Product Change Notification

Product Group: SIL/Fri Mar 10, 2023/PCN-SIL-014-2023-REV-0

Vishay Siliconix Announces New Material of Solder Paste & Stamp Clip for Commercial Power MOSFETs in PowerPAK® SO-8L Package

SDI Etch Clip

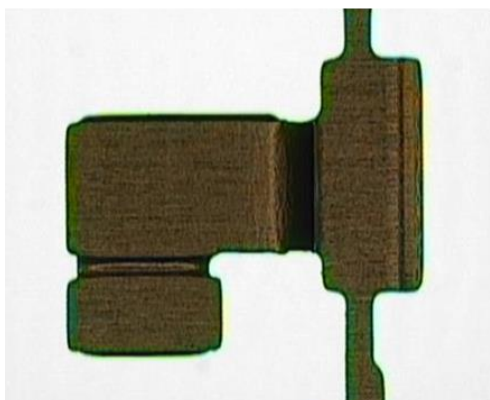
Besides, the stamp clip from PDE, "37-4365-1", is assembled in PowerPAK® SO-8L package with 2mil die for commercial products at Simconix. PDE

The Pictures of “37-4365-1” for SDI Etch Clip and PDE Stamp Clip:
